Town of Hilton Head Island

Board of Zoning Appeals Meeting

Monday, September 29, 2025, 2:30 PM

VAR-000830-2025 – Request from Richard Dietrich of The Renovators of SC, on behalf of Andrew and Kimberly Zekany, owners of 77 Sandcastle Court, also identified as Beaufort County Tax Map Parcel R511 009 000 1134 0000, for a variance from LMO Section 16-5-102.D, Adjacent Use Setback Standards, to allow a proposed home to encroach into each side adjacent use setback angle by approximately one foot and four inches, for a total encroachment of two feet and eight inches.
7. **Public Comment - Non Agenda Items**
8. **Board Business**
9. **Staff Reports**
 - a. Update on LMO Priority Amendments
10. **Adjournment**

A TREE AND TOPOGRAPHIC LAND SURVEY
OF
LOT 28 SANDCASTLE COURT
A PORTION OF
SANDCASTLES BY THE SEA
FOLLY FIELD ROAD

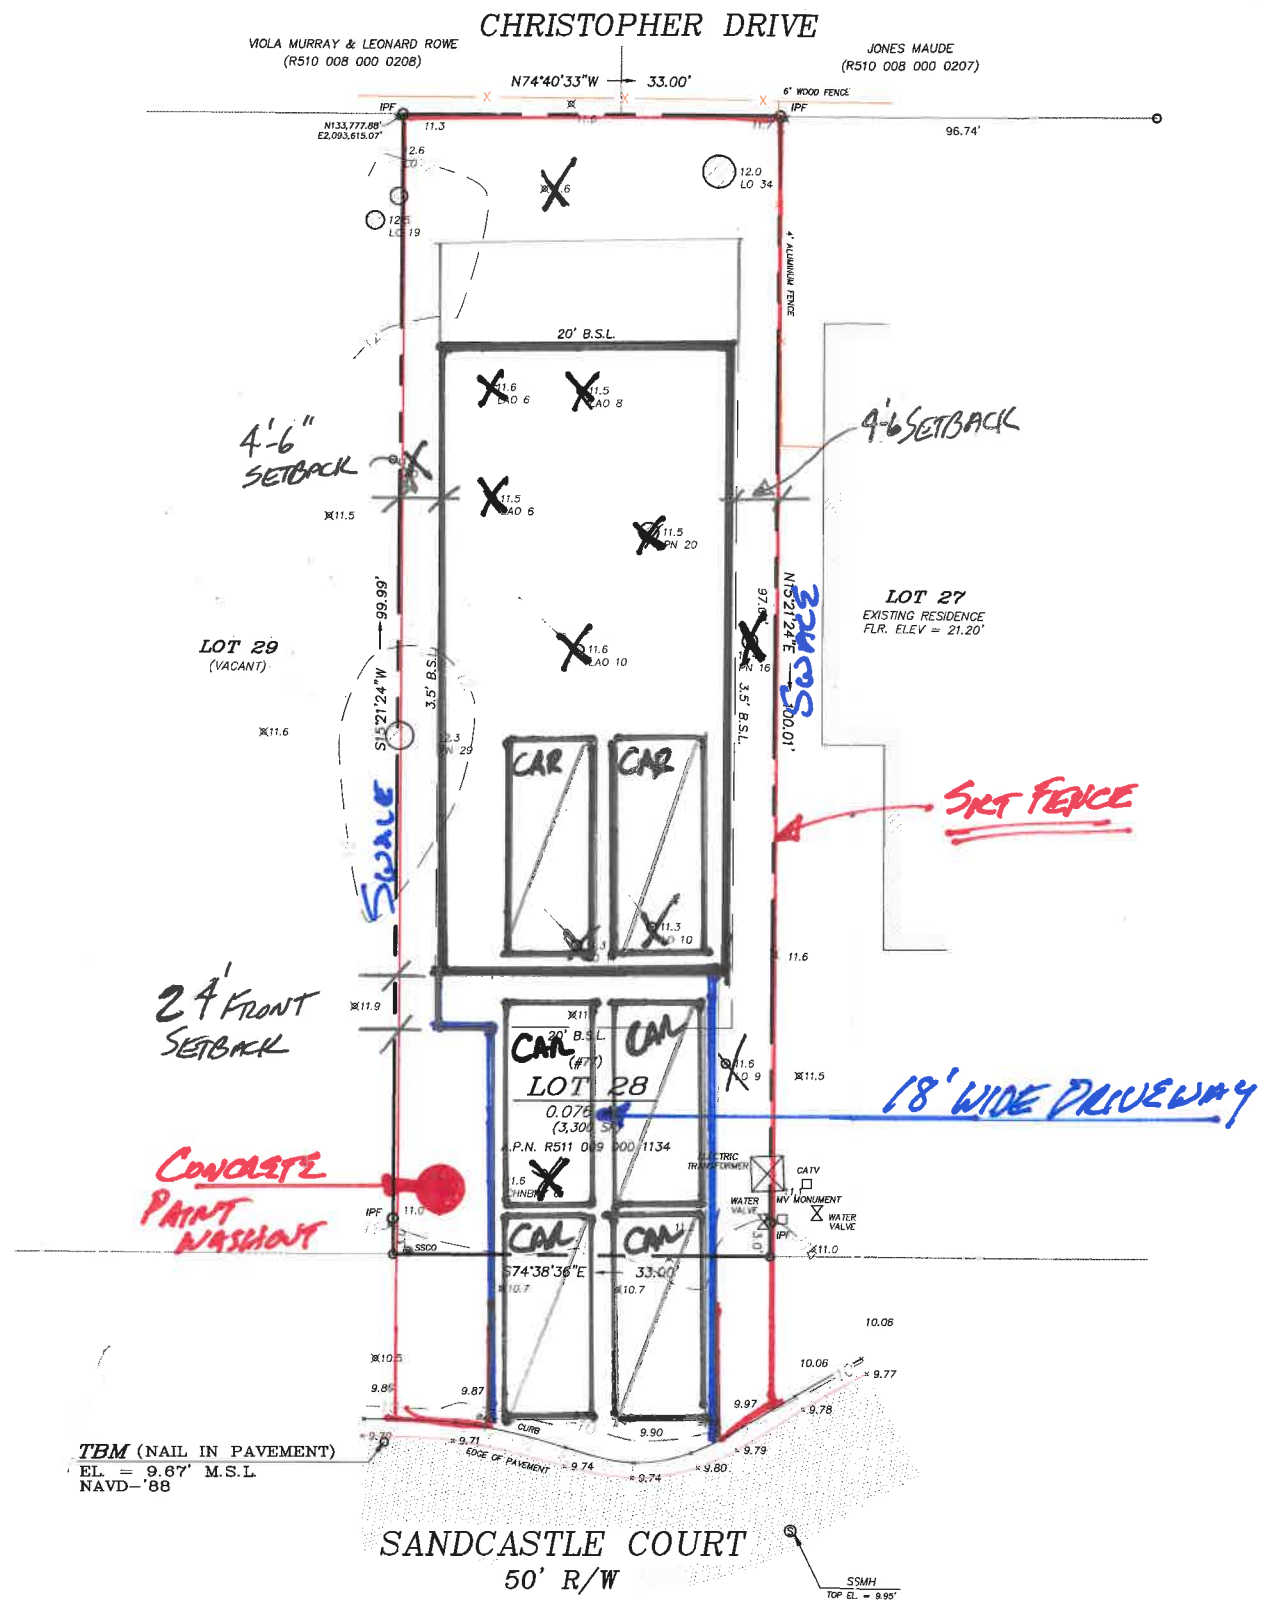
REVIEW ITEM	STATUS	REVIEWER
Community Development - Site Plan v.1 Site Plans - CDIC Correction: Planning - Melissa Paul-Leto (6/26/25) - Not Resolved Comments: LMO Section 16-5-102.C and D – The required adjacent use setback angle is 75 degrees. The required adjacent street setback angle is 60 degrees. Provide elevations demonstrating the proposed building meets this requirement. Correction: Planning - Melissa Paul-Leto (6/26/25) - Not Resolved Comments: LMO Section 16-3-105.(Letter) - The maximum building height is 45 feet. Provide an elevation showing the proposed building height, measured from 13 feet above Mean Sea Level using NAVD 88 vertical datum. If the proposed height is within 10% of the maximum allowed, a final height survey will be required prior to a Certificate of Occupancy is issued to make sure the building was not constructed higher than the maximum allowed.	Corrections Required	Melissa Paul-Leto Ph: 843-341-4625 email: melissapl@hiltonheadislandsc.gov

Floodplain Review v.1 Building Plans Floodplain Review Correction: Floodplain Management - Shari Mendrick (6/30/25) - Not Resolved Comments: This parcel lies wholly in Flood Zone X-Shaded. Remove reference to 7' bfe from note 1 on the tree and topo survey (site plan).	Corrections Required	Shari Mendrick Ph: 843-341-4687 email: sharim@hiltonheadislandsc.gov
NPDES Review v.1 NPDES Engineering Review Correction: Stormwater NPDES - Jacob Terry (6/20/25) - Not Resolved Comments: Demonstrate on the site plan the location of the construction exit.	Corrections Required	Jacob Terry email: jacobt@hiltonheadislandsc.gov

LEFT ELEVATION
SCALE: 1/4" = 1'-0"

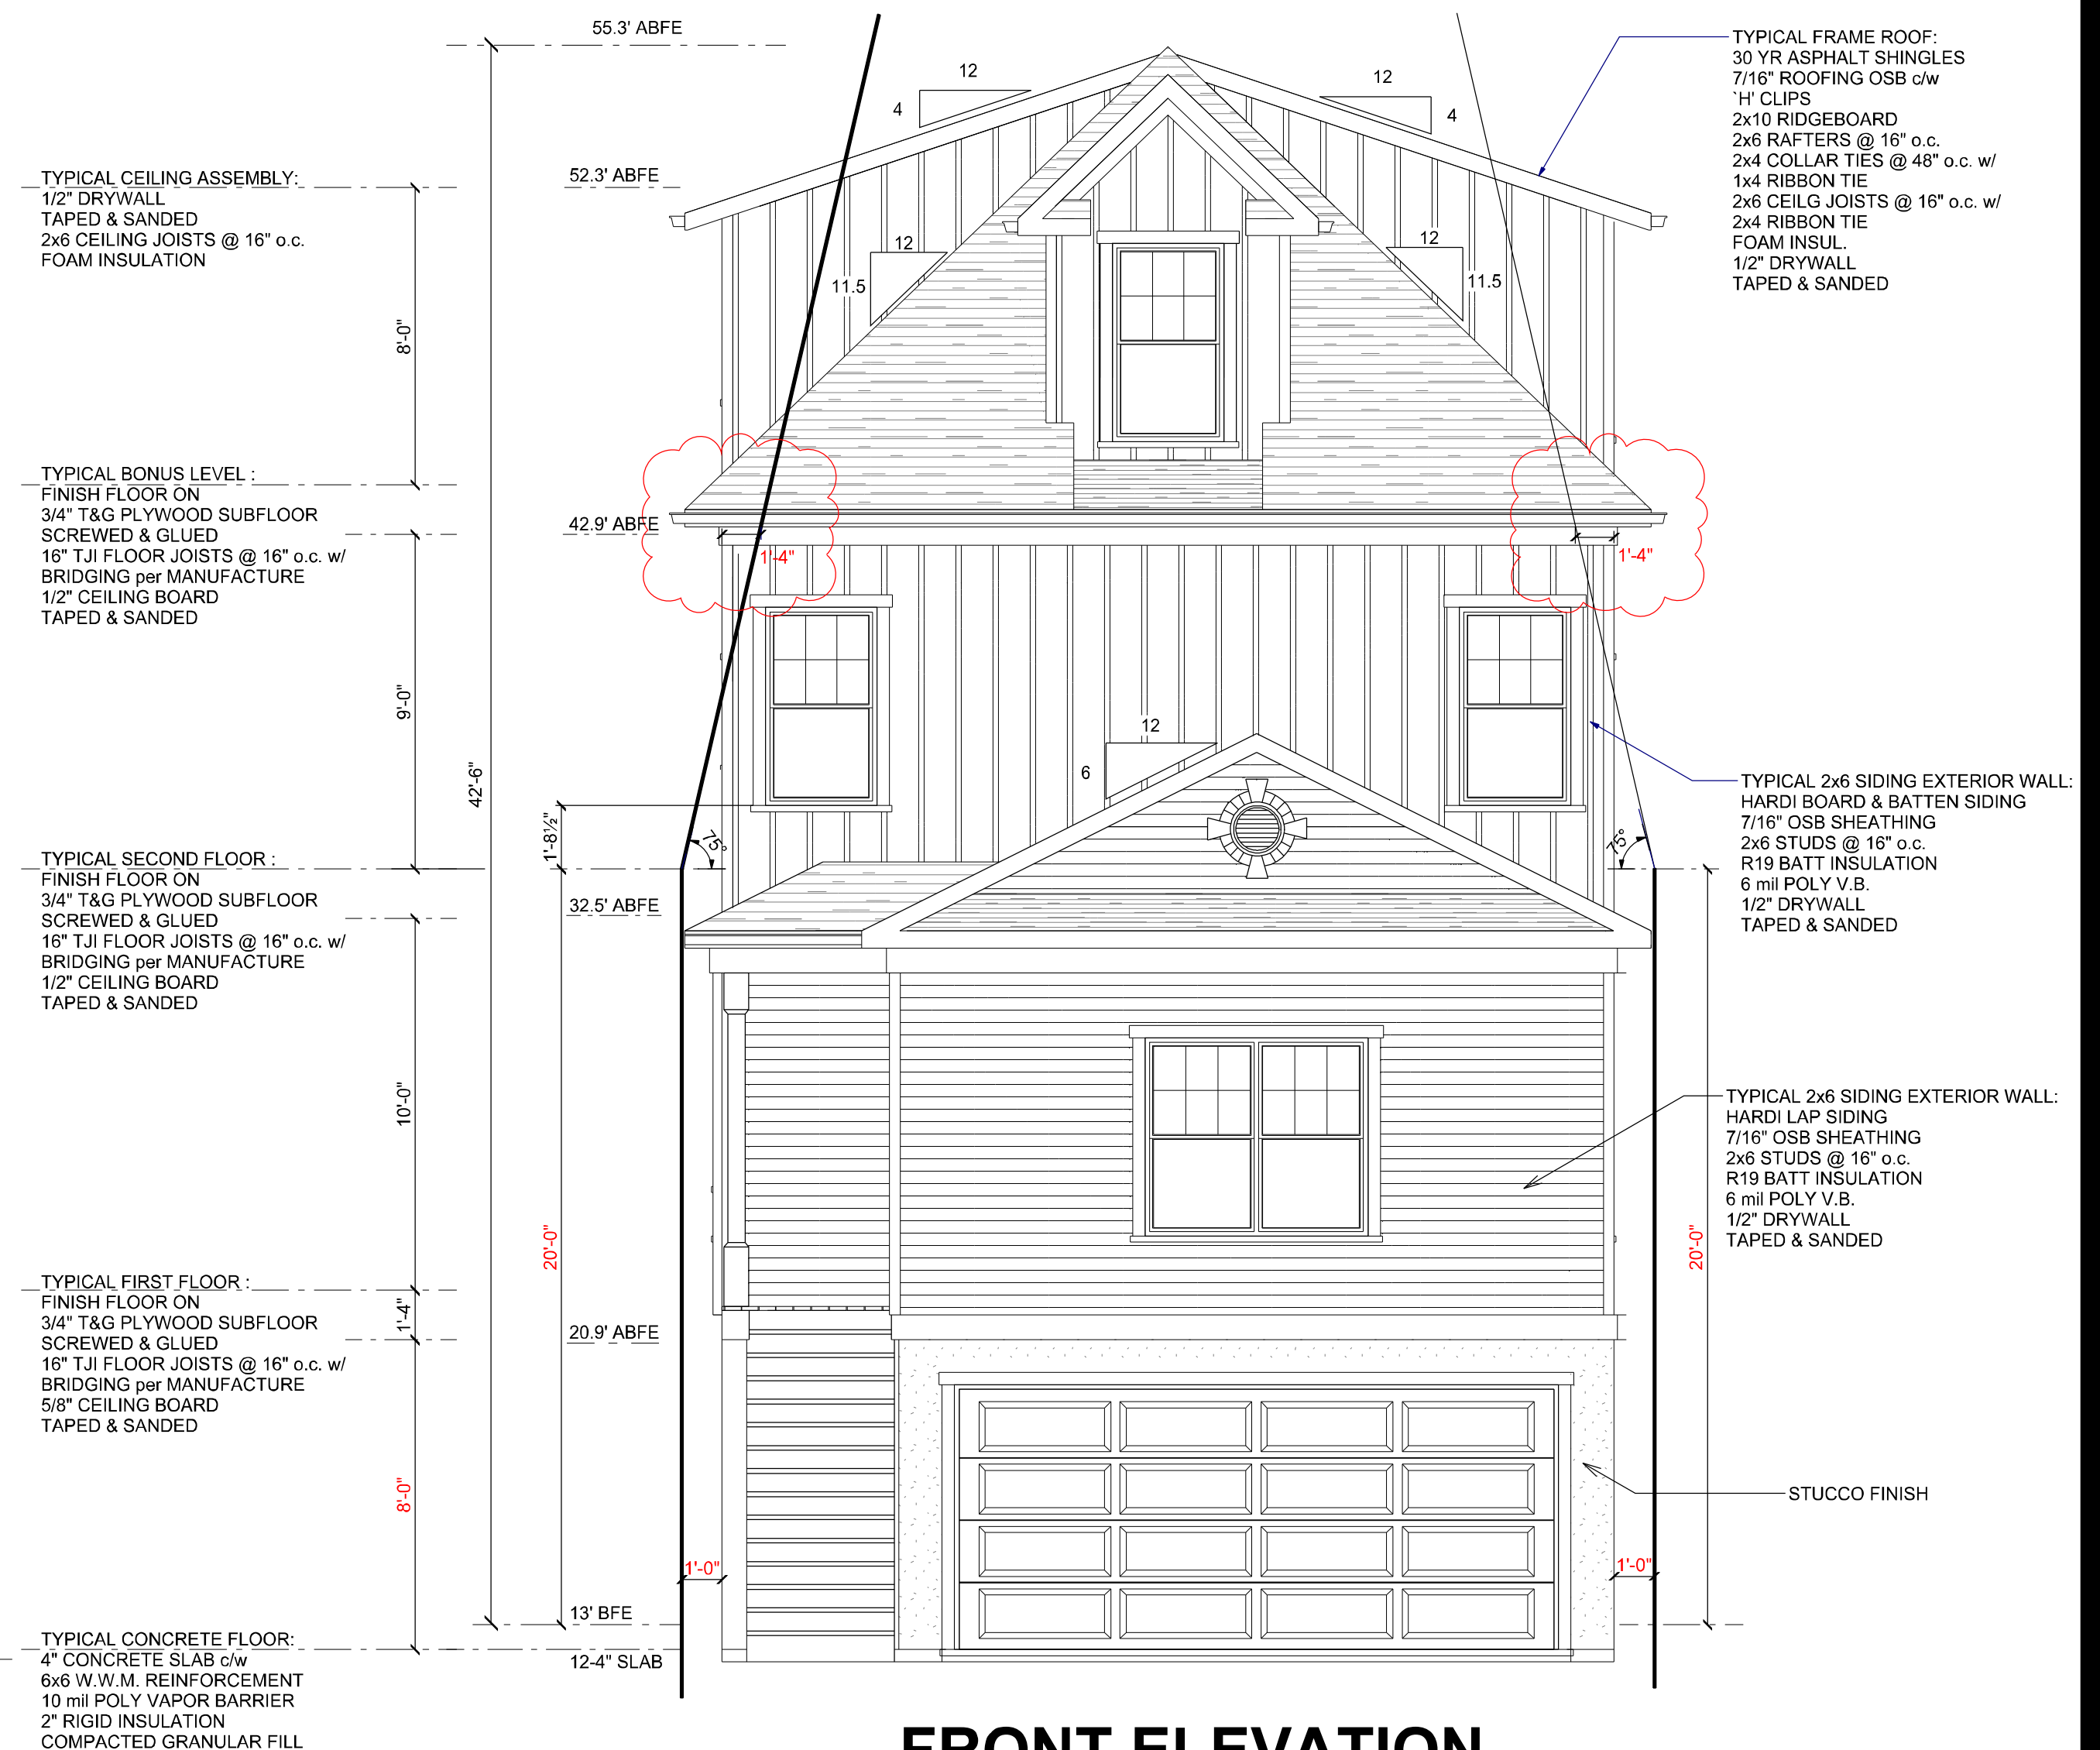
The variance request is for an encroachment of up to 1'-4" into the 75 degree setback angle on both sides of the home at the top of the exterior walls on the 2nd floor. (See attached drawing for clarification.)

Sandcastle by The Sea property has extraordinary & exceptional differences due to the lot size of 33' x 99'. If you were to draw a line up 20' above the 13' BFE for the adjacent setback/buffer you would not have a desirable floorplan that would be accepted by our client and the HOA for Sandcastle by The Sea. The adjacent setback angle requirement is an exceptional condition within Sandcastle now that 88% of the homes have already been
